Documentation of Public Meeting

Parmer Lane (Farm-to-Market 734)

From Mopac (Loop 1) To Whitestone Boulevard

In-Person Meeting: August 1, 2024, 5 p.m. to 7 p.m.

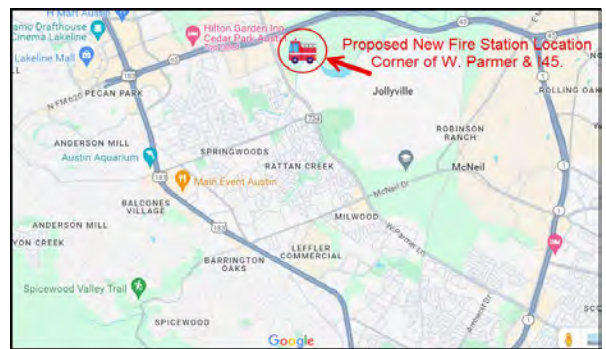
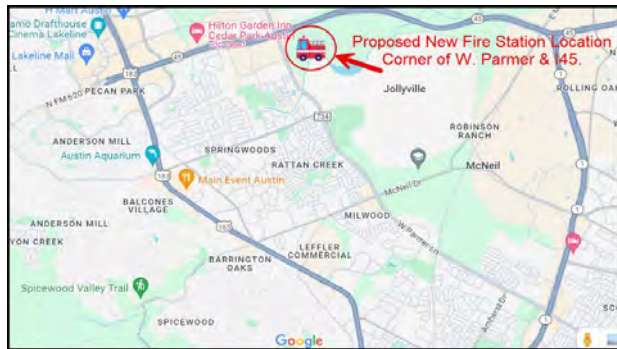
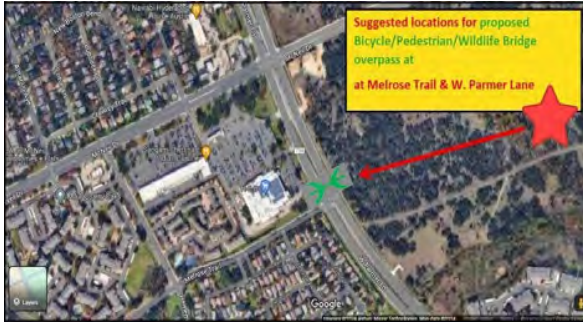
- At previous 60% design, for the City of Austin local side streets, the design engineer used the City's Transportation Criteria Manual in the design of intersections for details like

corner radii and curb ramp placement. We would expect that would be a part of the corridor study and future designs. In particular, the City would want the Parmer design to tie into the bicycle and pedestrian facilities planned for each cross street, such as Lakeline Blvd, which has planned improvements.
